Notice of Allowability

10/669,999

HARNEY, DONALD

EXAMINER'S AMENDMENT

Fig. 5

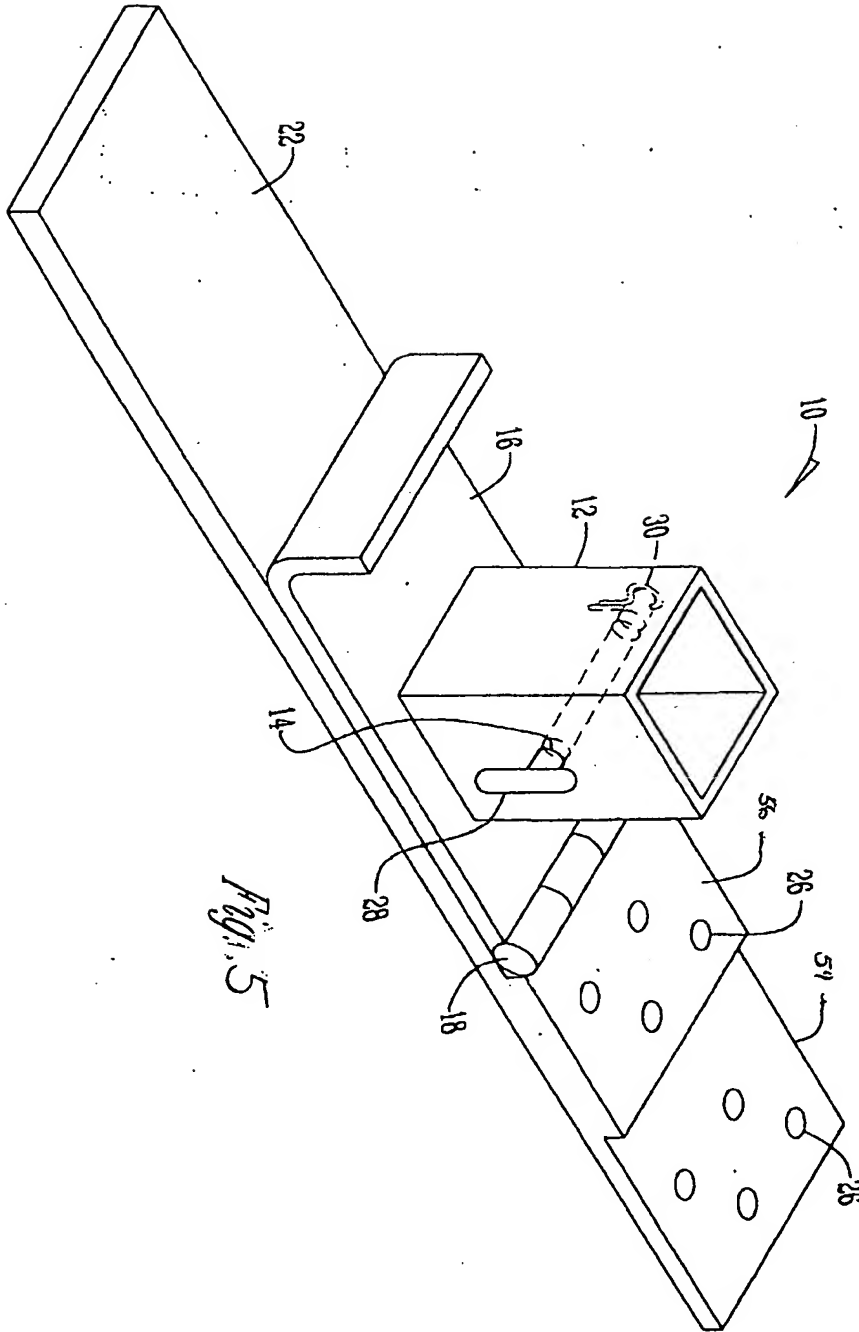
The following changes to the drawings have been approved by the examiner and agreed upon by applicant: Applicant must amend the drawings to reflect the sleeve received "onto", i.e., about the sleeve. Also, newly submitted Figure 5 must be labeled as "new", so as to properly be entered. In order to avoid abandonment of the application, applicant must make these above agreed upon drawing changes.
